Access Compliance Report

Public Rights-of-Way

Intersection ID: N/A	Main Street: E MARTIN LUTHER KING JR BV	Cross Street: S BREVARD ST	Location: W
ADA ID: A561109547C0	Ramp Type: BlendTrans1	Initial Pass/Fail: Fail	Overall Compliance: No
		Severity Score: 25

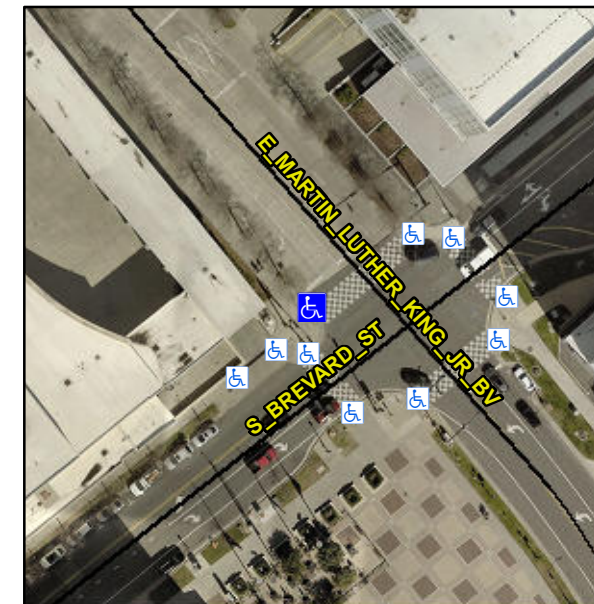
Not Found, R304.5.3

Compliance	Description	Data	Compliance	Description	Data
N/A	Ramp Length (in)	72.0	Yes	BlendTrans Slope (%)	3.9
Yes	Ramp Width (in)	48.0	No	BlendTrans XSlope (%)	7.3
N/A	Flare Type LT	N/A	N/A	Flare Type RT	N/A
N/A	Flare Slope LT (%)	N/A	N/A	Flare Slope RT (%)	N/A
N/A	Flare Traversable LT?	No	N/A	Flare Traversable RT?	No
N/A	Landing Length (in)	N/A	N/A	DWS Provided?	N/A
N/A	Landing Width (in)	N/A	N/A	DWS Contrast?	N/A
N/A	Landing Slope (%)	N/A	N/A	DWS Length (in)	N/A
N/A	Landing X Slope (%)	N/A	N/A	DWS Full Width?	N/A
N/A	Landing Curb? (Y/N)	N/A	N/A	DWS Offset (in)	N/A
N/A	Shared Landing?	N/A			
N/A	Gutter Ponding?	N/A	N/A	Gutter Slope (%)	N/A
N/A	Gutter Lip Ht (in)	N/A	N/A	Gutter X Slope (%)	N/A
N/A	Painted X Walk1?	Yes	N/A	Painted X Walk2?	N/A
	X Walk 1 Direction	To NE		X Walk 2 Direction	N/A
	X Walk 1 Width (in)	144.0		X Walk 2 Width (in)	N/A
	X Walk 1 Slope (%)	3.2		X Walk 2 Slope (%)	N/A
	X Walk 1 X Slope (%)	3.3		X Walk 2 X Slope (%)	N/A

N/A	Ramp inside XWalk1?	Yes	N/A	Ramp inside XWalk2?	N/A
	Road Slope (%)	3.3		Clear Space?	N/A
	Road X Slope (%)	3.2	N/A	Clear Space to XWalk (in)	N/A
N/A	Any Obstructions?	N/A	N/A	Storm Grate/Utility Hazard?	N/A
	Obstruction Type			Storm Grate/Utility Type	
		N/A			N/A
			Yes	Surface Condition? (G/P)	Good
			No	Curb Slope (%)	11.9

Remove & Replace Curb Ramp With Two New Directional Ramps or Equivalent.
